Re: Review of findings of Environmental Noise Impact Assessment of Proposed Albany Wind Energy Facility Conducted By Enviro Acoustic Research.

- 1.1** The following report was commissioned at the request of Theo Fischer of EScience Associates (Pty) Ltd on behalf of Indalo Chairman of Indalo PGRA and .
- 1.2** This report has been written to document the review of the Noise Impact Assessment conducted by Enviro Acoustic Research (EAR)”, compiled as specialist report as part of the EIR dated March 2020 and submitted for public comment in April 2020 as part of Environmental Impact Assessment application Albany Wind Farm Near Port Elizabeth, Eastern Cape Province (DEFF Reference Number: 14/12/16/3/3/2/1131) henceforth referred to as the Albany NIA.

Figure 8-1: Wind Turbine Locations for the Albany WEF – Layout Revision 8.5

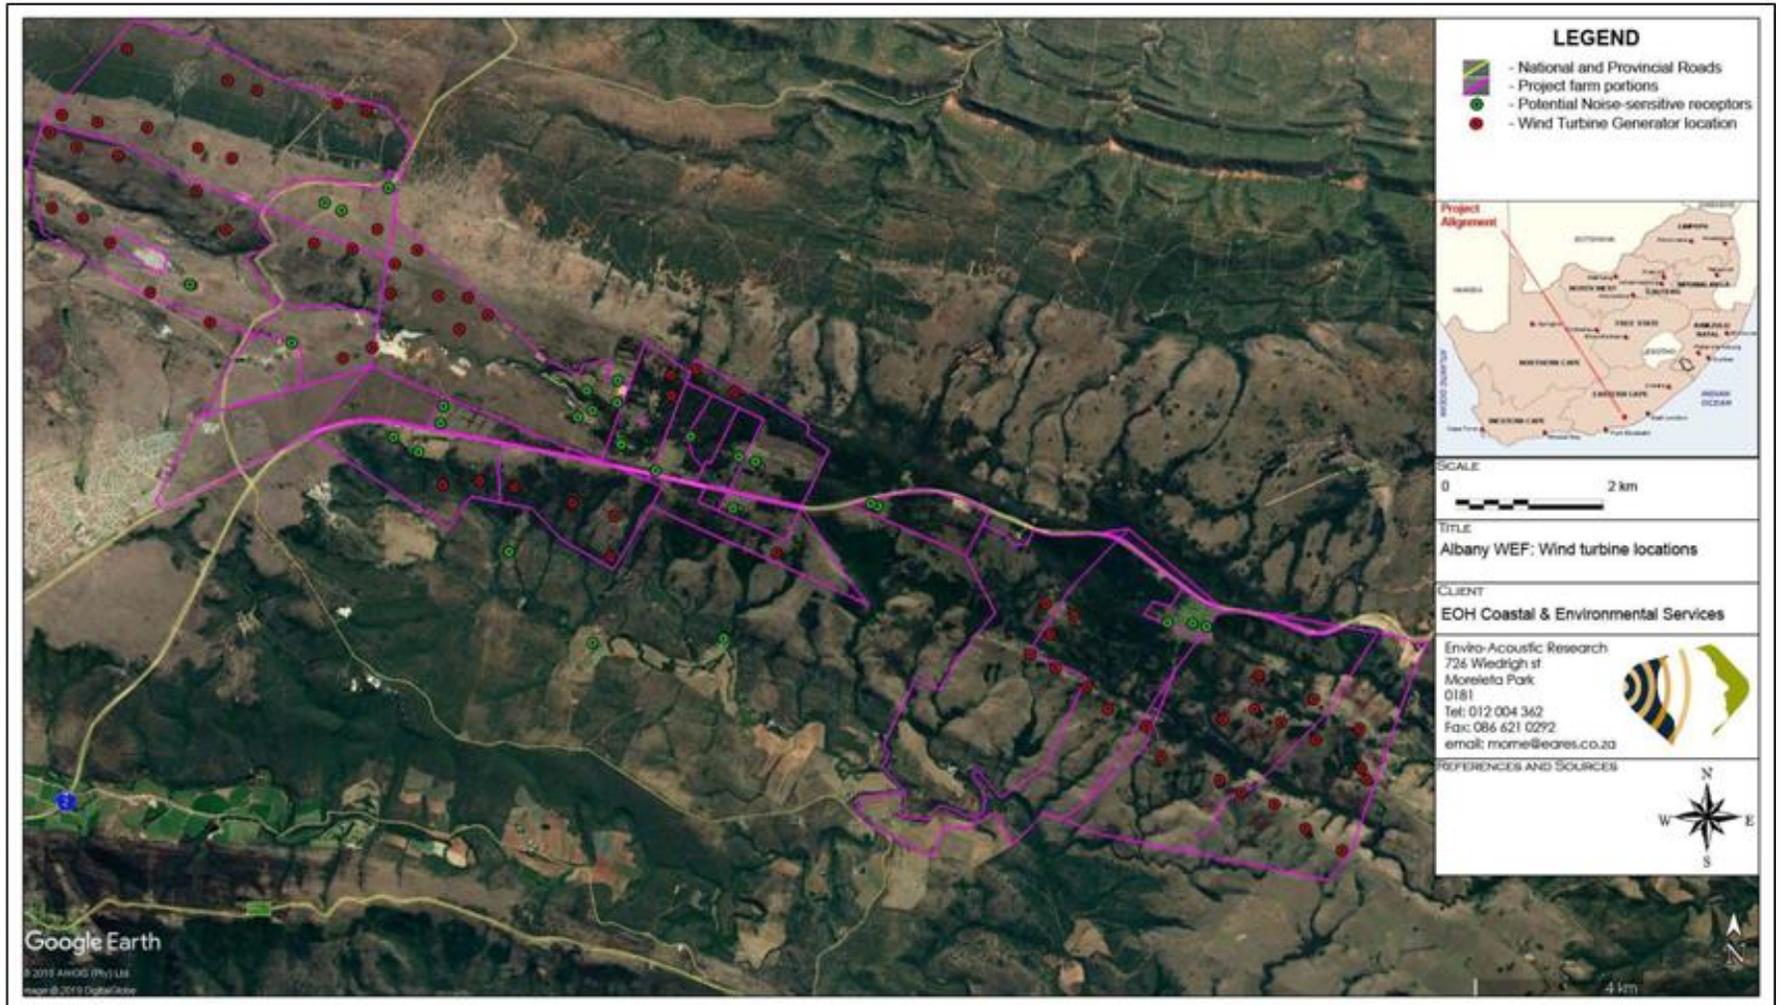
2. Further, in **Figure 8-1** is similarly inaccurate in that there are more than 20 noise sensitive location near to the facility including formal protected areas as well as private game reserves. The turbines will be within 5 km of the following reserves (refer figure below):

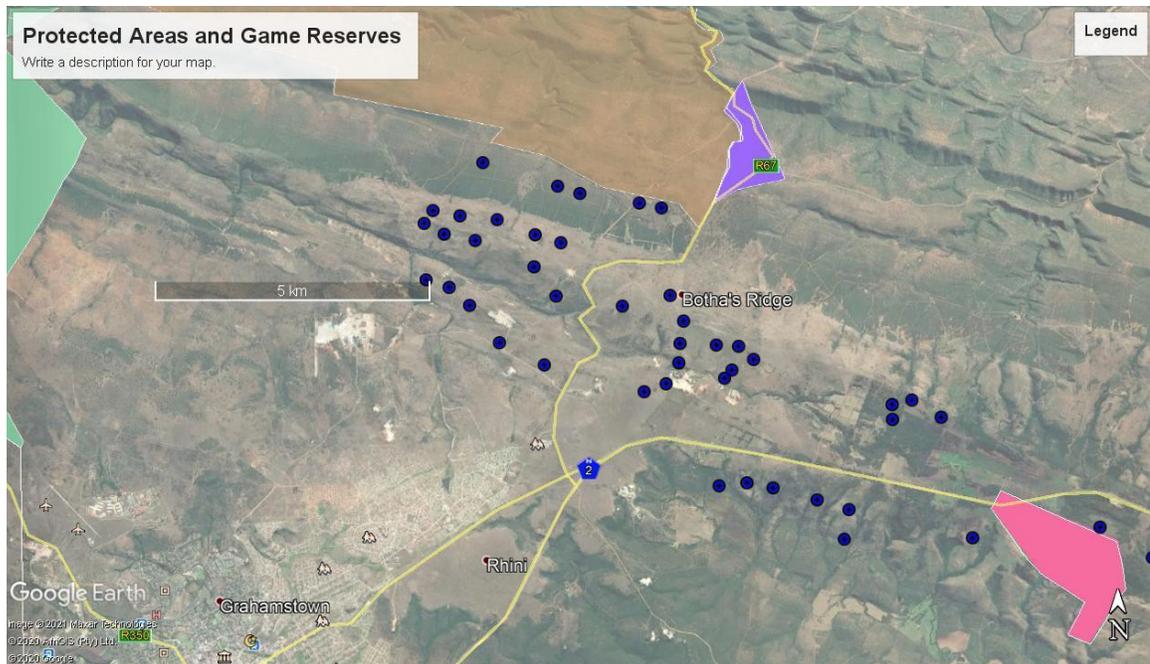
- A.12.1. Kwandwe South Game Reserve.
- A.12.2. Blaauwkrantz Local Authority Nature Reserve
- A.12.3. Beggars Bush Forest Reserve (turbines straddling this reserve)
- A.12.4. Numerous game farms and lodges.

Figure 8-4: Projected conceptual noise rating levels of the Albany WEF during operation

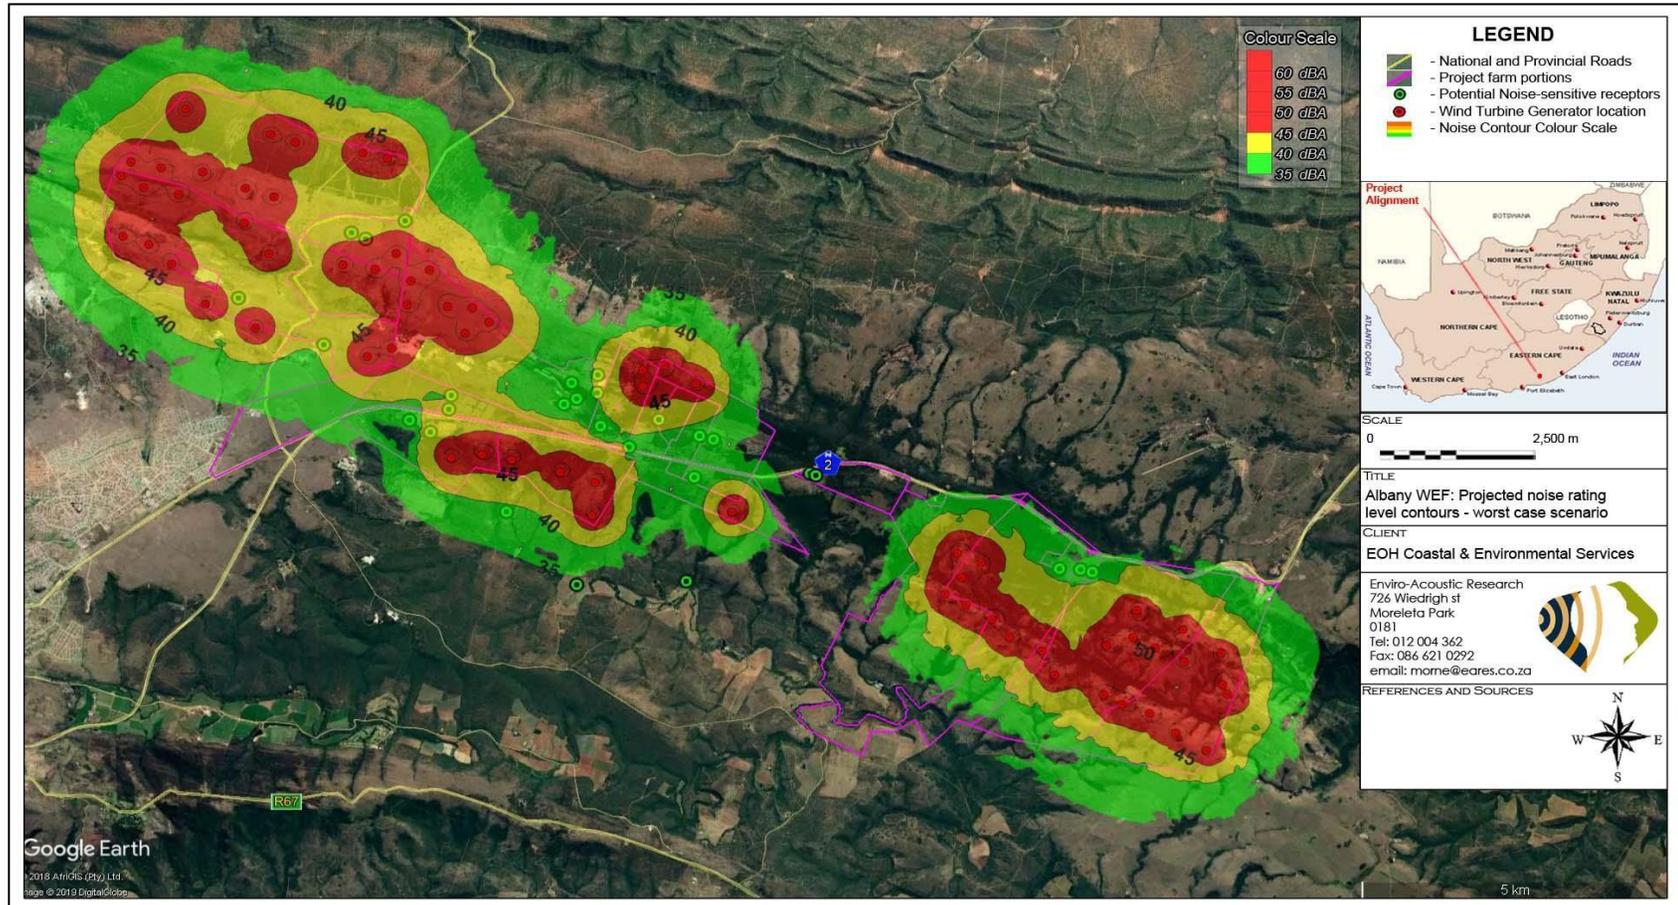
2.7.1 Figure 8.4 below provides “Projected conceptual noise rating levels of the Albany WEF during operation”. The NIA report does not indicate how the “conceptual noise rating levels of the Albany WEF during operation” as illustrated in Figure 8-4 have been derived. It would be normal professional practice to use a calculation based on a series of equations (for example Concawe or ISO 9613-2) or a software

In the report no attempts are made to explain the methodology used and thus Figure 8.4 is of little use as there is no way of verifying its veracity. The lack of a description of the methodology used in determining the turbine noise as function of distance, topography and weather leaves the study falling short of normal practice as well as the basic scientific principle of reproducibility, the lack of which does not allow meaningful peer review. It is further concerning that the figure refers to “conceptual” noise rating as opposed to “predicted”, “modelled” or “calculated” which may imply that it only is a conceptual representation giving an indicative assessment of noise impact when in fact a verifiable quantitative method is required.

2.7.2 It should further to be noted that it is a requirement of NEMA EIA Regulations 385 Regulation 33 that stipulates “a description of the methodology adopted in preparing the report or carrying out the specialised process” is to be provided. Thus the lack of the methodology used in determining the noise rating levels of the Albany WEF not only leaves the report falling short of professional practice, and scientific principles, but further also leaves non-compliant with applicable EIA Regulations (and in turn thus similarly affects the EIA itself).

This is in contradiction to Figure 8.4 above in which at least two locations are within the 50 dBA contour and 13 within 800 metres of various turbines. Under this circumstance Table 9-3 is wholly incorrect.

Example of the effect of wind on the propagation of low frequency rotational harmonic noise from a modern large-scale Horizontal Axis Wind Turbine (University of Notre Dame , Course work AME 40530).

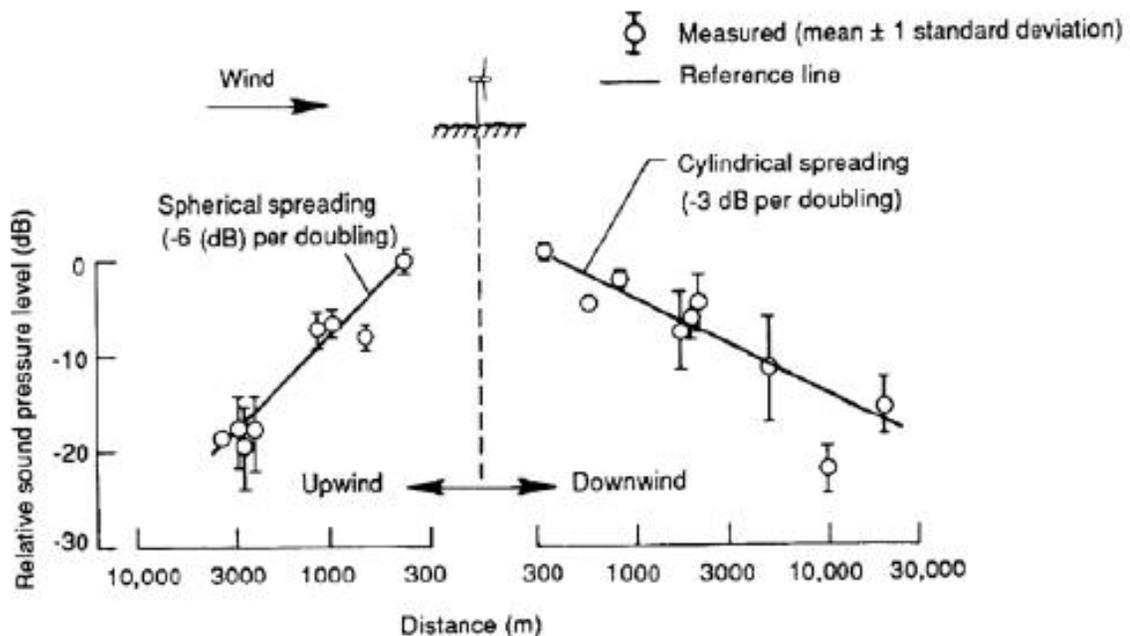
2.8.1 The report states that “Cumulative noise impacts generally only occur when noise sources (such as other wind turbines) are closer than 2,000 m from each other (around 1,000 m from the conceptual receptor located between them). The cumulative impact also only affects the area between the wind turbines of the various wind farms.”

This statement is incorrect. The noise from wind turbines decreases by 6 dB per doubling of distance for noise emissions upwind and by 3 dB per doubling of distance downwind (University of Notre Dame , Course work AME 40530)¹⁴.

Figure 8-5: Effect of distance between wind turbines – potential cumulative noise

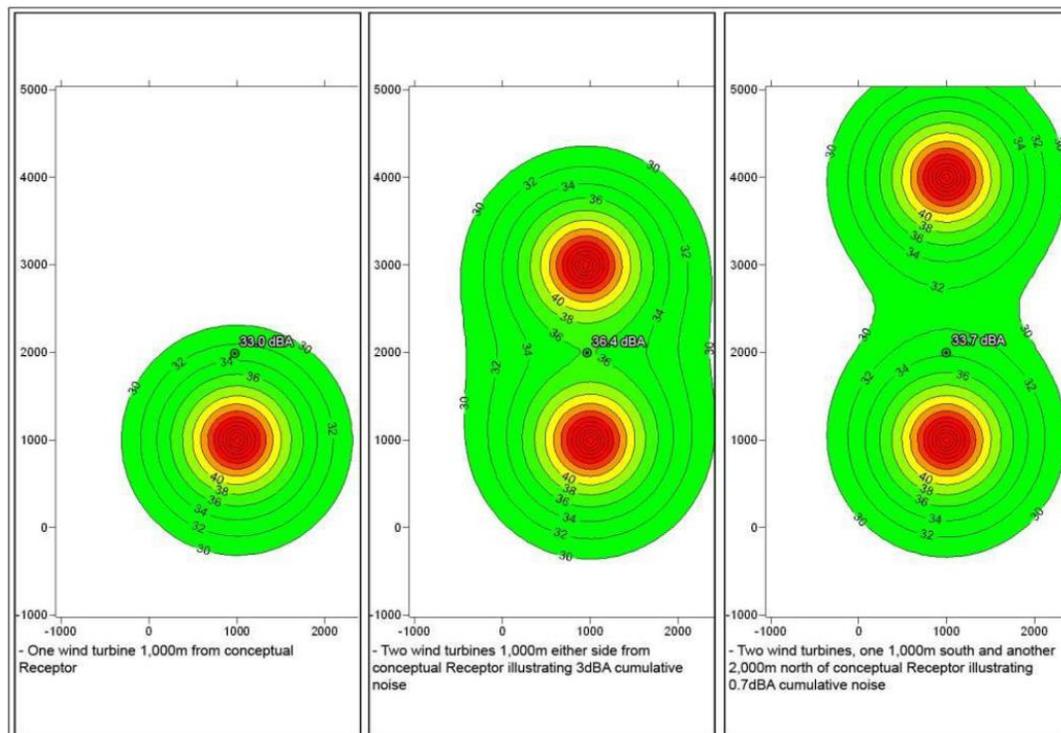
2.8.3 The report states that “If the wind turbines of one wind farm are further than 2,000m from the wind turbines of the other wind farm, the magnitude (and subsequently the significance) of the cumulative noise impact is reduced. If the distance between the wind turbines of two wind farms are further than 4,000m, cumulative noise impacts are non-existent. This is illustrated in Figure 8-5.”

This is patently incorrect: from the calculation above if the distance between the wind turbines of two farms are 4000 m then, depending on topography, the effect will be 12 dBA above ambient.

Referring to Figure 8-5 : This figure cannot be correct. At a distance of 2000 m from one turbine the sound pressure level is 32 dBA which is far less than the actual value calculated here.
